Contract #: 04-0120F4Cty: SF/ALA Rte: 80 PM: 13.2/13.9File #: 69.25B**QUALITY ASSURANCE -- NON-CONFORMANCE REPORT****Location:** Changxing Island, Shanghai, P.R. China**Report No:** NCR-000609**Prime Contractor:** American Bridge/Fluor Enterprises, a JV**Date:** 06-Jan-2010**Submitting Contractor:** Zhenhua Port Machinery Company, Ltd (ZPMC), Changxing Island**NCR #:** ZPMC-0582**Type of problem:**

Reference Description: ZPMC performed welding repair of an MT Transverse Indication without the prior approval of the Engineer for a Lift 12 LD

Subject: NCR No. ZPMC-0582

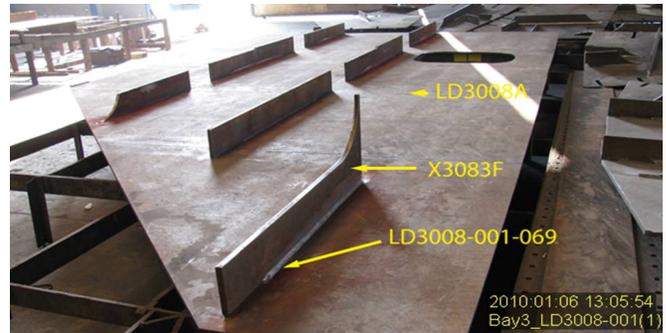
During random in progress inspection, this Quality Assurance (QA) Inspector observed the following issues:

- ZPMC Production Personnel was observed excavating a Longitudinal Linear MT Indication identified by ZPMC's MT Technician as a transverse crack, without having a Critical Weld Repair (CWR).
- One (1) Longitudinal linear indication measuring approximately 8mm in length.
- The weld is identified as: LD3008-001-069.
- These welds are a Fillet Weld type joining the Longitudinal Diaphragm Stiffener (X3083F) to Longitudinal Diaphragm (LD3008A) web plate.
- The Longitudinal Diaphragm is located in the Sub-Assembly Bay 3.

In this case, the inspector observed ZPMC performing exploratory grinding to determine if the indication was actually a crack which does not require approval. When ZPMC determined it was a crack they generated a CWR for Caltrans approval before proceeding with work. Attached is the CWR showing that Caltrans reviewed the CWR. Based on this misunderstanding ZPMC requests that this NCR be withdrawn and closed.

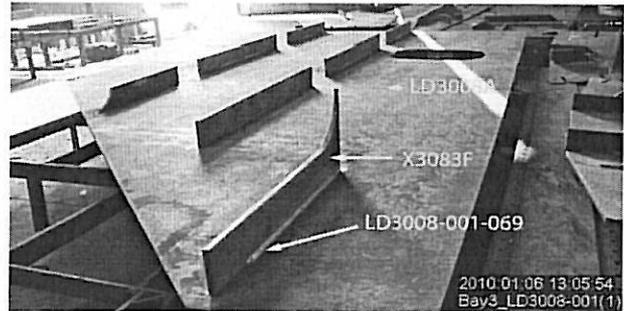
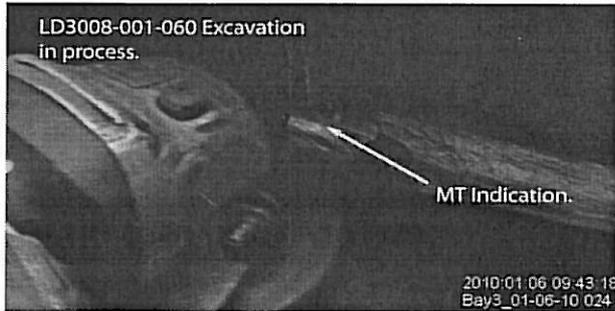
During random in progress inspection, this Quality Assurance (QA) Inspector observed the following issues:

- ZPMC Production Personnel was observed excavating a Longitudinal Linear MT Indication identified by ZPMC's MT Technician as a transverse crack, without having a Critical Weld Repair (CWR).
- One (1) Longitudinal linear indication measuring approximately 8mm in length.
- The weld is identified as: LD3008-001-069.
- These welds are a Fillet Weld type joining the Longitudinal Diaphragm Stiffener (X3083F) to Longitudinal Diaphragm (LD3008A) web plate.
- The Longitudinal Diaphragm is located in the Sub-Assembly Bay 3.

Draft of Welding Discontinuity:

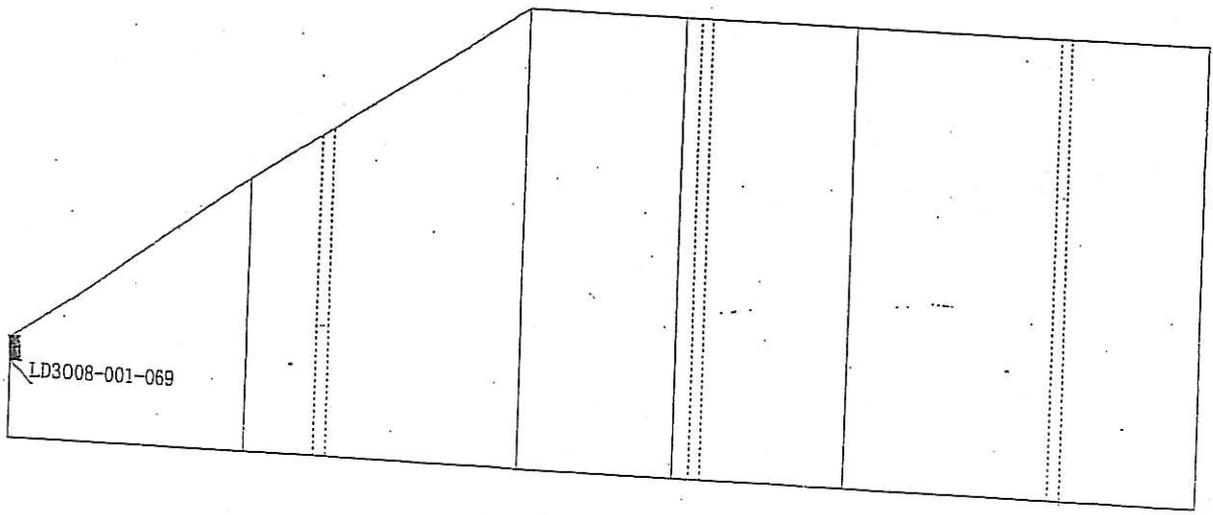
One transverse crack was found by use of MT on LD3008-001-069

1. 火焰加热时,水汽没有完全的去除了或者这个区域预热不够;
1. Moisture wasn't completely removed during drying operation (preheating) or the area wasn't preheated sufficiently.

1. QC and a Lead CWI shall be present, direct and supervise all grinding and welding operations during this repair to ensure the repair is per the disposition requirements.

2. QC and a Lead CWI shall have an approved copy of the CWR in hand prior to the repair.
3. Remove paint ≥ 25 mm in all direction of HAZ prior to MT.
4. Clean the excavation area of all loose debris including MT powder. Preheat to 65° C before removing cracks by grinding and it applied to all the repair process. Repair area shall extend a minimum of 50mm beyond each end of single crack repairs.

5. If base metal is damaged by grinding, the damaged area shall be ground clean prior to performing weld repair.
6. Prepare excavation in accordance with the New Repair Procedure prior to welding.

7. Before this repair, Verify with VT and MT repair areas are defects free, and also MT shall be performed on the base metal laying abroad cracks to ensure that no cracks were propagated to the base metal. Separate CWR approval is needed if cracks are found in the base metal, and only after this new CWR's approval can continue the repair.

8. Clean excavation area of all loose debris including MT powder after excavation. Preheat and weld according to repair WPS, the preheat shall between 160° C-230° C.

9. If a crack still present and excavation have reached (2/3T+2)mm maximum, the grinding work shall be ceased. Prepare excavation that all metal is ground clean to a smooth, shiny metal finish and starts and stops are tapered to a 1:1 slope. Weld first side of repair according to approved WPS, and the preheat temperature be 160° C at least. Grind from the opposite side until sound weld metal is reached and perform 100% MT of excavation to ensure no crack exists. Prepare excavation that all metal is ground-clean to a smooth, shiny metal finish and starts and stops are tapered to a 1:1 slope. Weld opposite side of repair according to approved WPS.

10. Perform post weld heating according to repair WPS, the postheat shall between 230° C-315° C and for one hour minimum.
11. Allow the weld to cool to ambient temperature gradually. Control cooling rate after PWHT to no more than 50° C per hour.

12. Grind the repaired area flush with base metal or the adjacent weld after post weld heating.
13. Wait 48 hours at least after the repair area has cooled to ambient temperature before performing NDT.

14. Perform VT, UT and MT inspection to all repair area according to Contract Drawings along with all additional NDT required by the applicable notes Special Provision Section 10-1.59 'Steel Structure', subsection 'Inspection testing'.
